## **APPENDIX E**

### **SUPPLEMENTAL DEC DATA**

# Technical Memorandum

**Re:** Assessment of Measures to Minimize East Park Habitat Impacts from the Yukon Avenue Connections

Existing Landfill Stormwater Management System  
**Figure E-1**

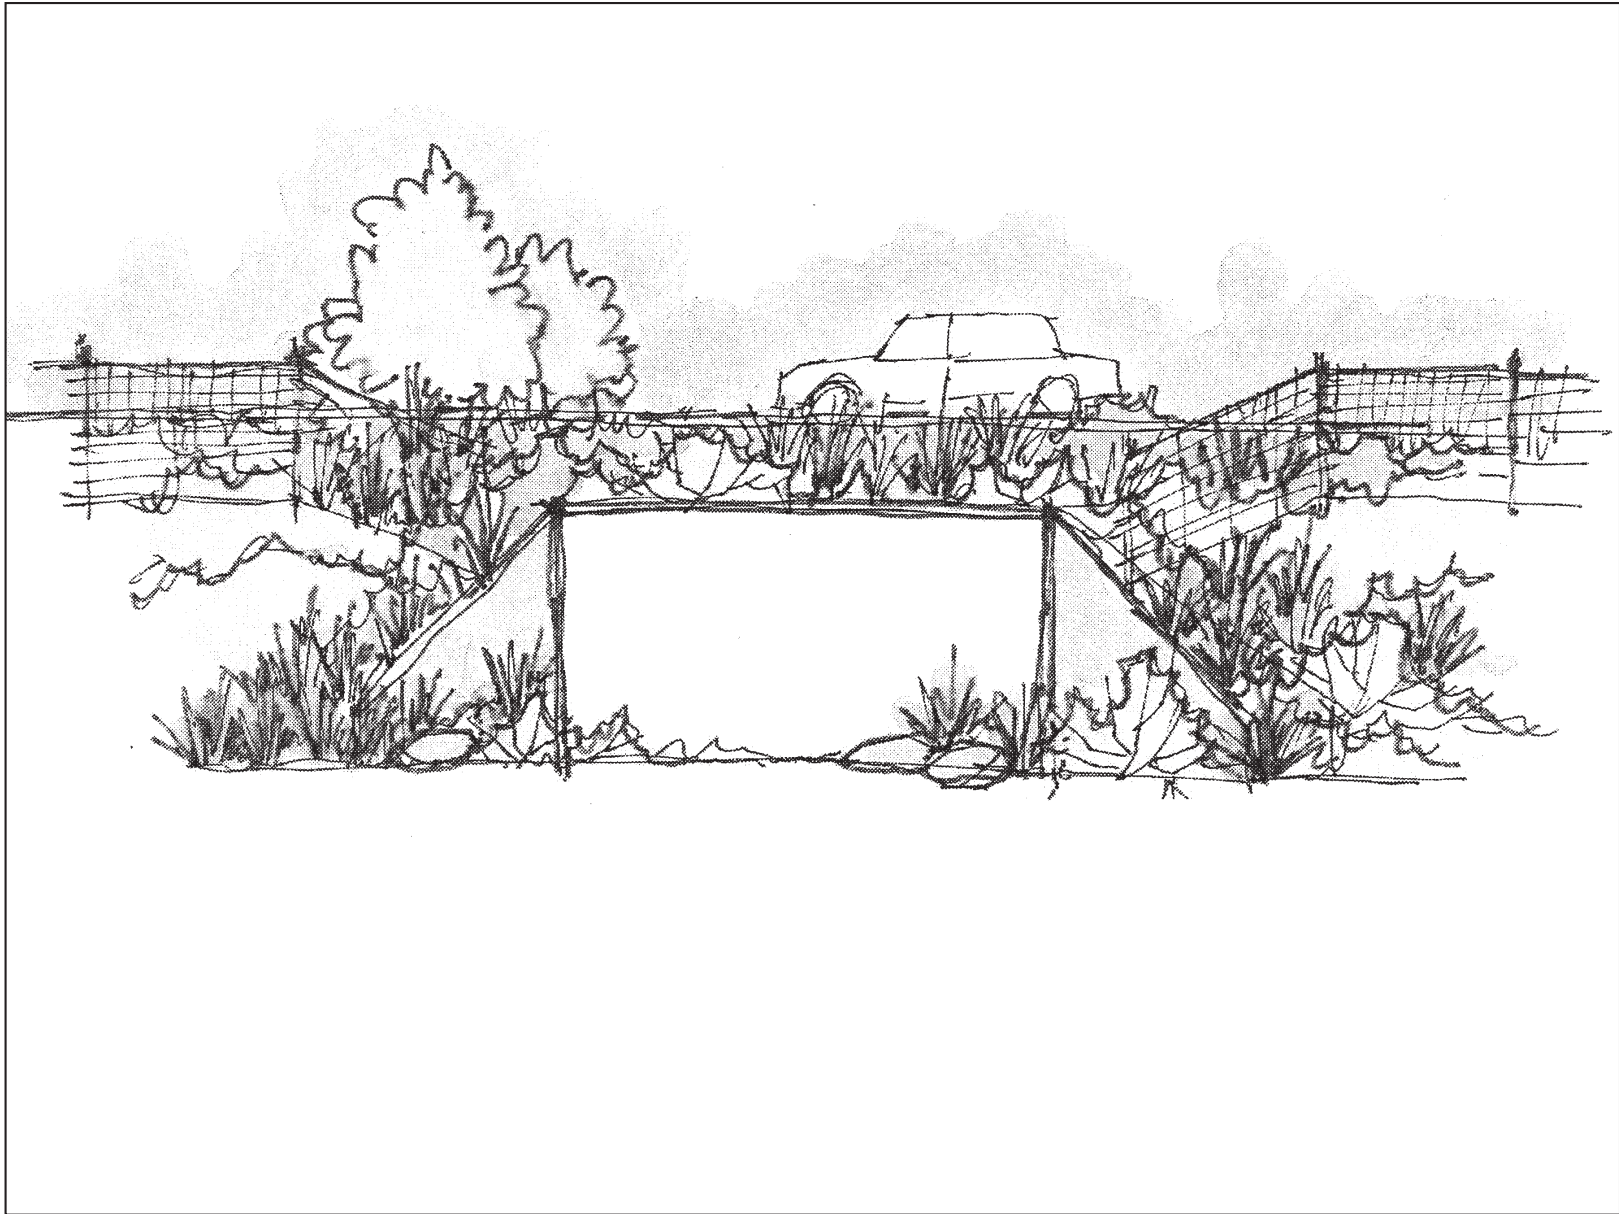
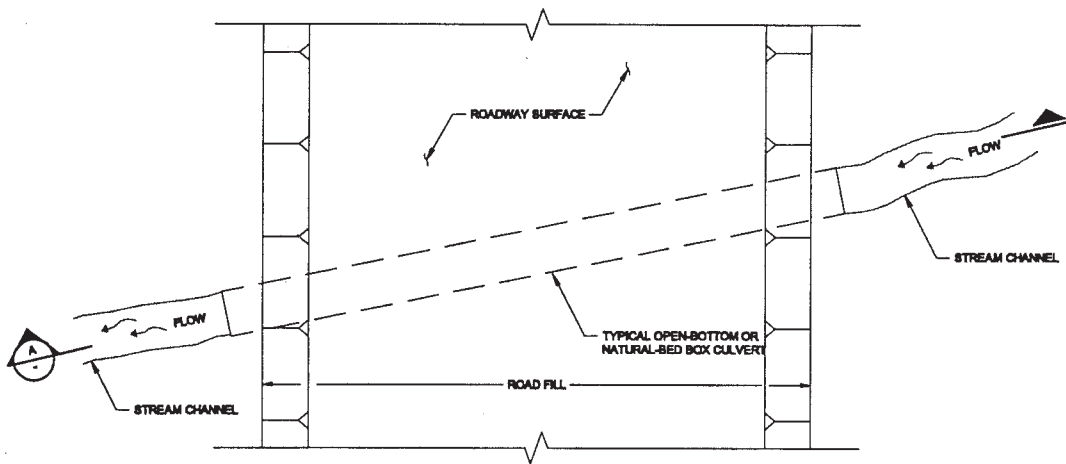
*“The portion of the Yukon Connection crossing between stormwater basins B1 and B2 entails extending the length of the existing 5-foot diameter culvert. While this may maintain a hydrologic connection, it does not appear that it would provide an adequate, suitable wildlife passage area. If species such as turtles and frogs do not find the culvert usable, they will be more likely to cross the road to migrate from basin to basin, which is likely to result in a significant increase in mortality to these species. The SEIS must evaluate the suitability of the expanded culvert as a wildlife conduit and explore design alternatives to avoid these impacts (e.g. wider culvert(s) or viaduct).”*

The proposed Yukon Avenue Connection in the road segment between Landfill Section 6/7 and Richmond Avenue would pass between stormwater drainage basins B1 and B2 (see Figure E-1). Currently, these basins are hydrologically connected by a 60-inch standard culvert. With the proposed project, the Yukon Avenue Connection would be installed as either a 2 lane (40-foot-wide) or 4 lane (60-foot-wide) park road. The proposed road would have little direct (filling) impact on the wetlands (estimated at 0.1 acres due to side slope grading with a four-lane-wide road). The limited impact is because this segment of the proposed road has been sited at an area that has already been developed as part of the Fresh Kills Landfill with a service road and the associated infrastructure (see Figure E-2). However, both of the basins, although structural in design, are hydraulically connected to adjoining wetlands and are part of the overall interconnected habitat system that exists east of Landfill Section 6/7, between the landfill and Richmond Avenue.

- Replacement of the existing 60-inch standard culvert with an open bottom box culvert with footings provided at each wall, thereby allowing natural substrate beneath it. The box culvert will be sized to provide enhanced hydraulic conductivity between stormwater basins B1 and B2, and wildlife passage above the permanent pool elevation (see Figures E-3 and E-4).
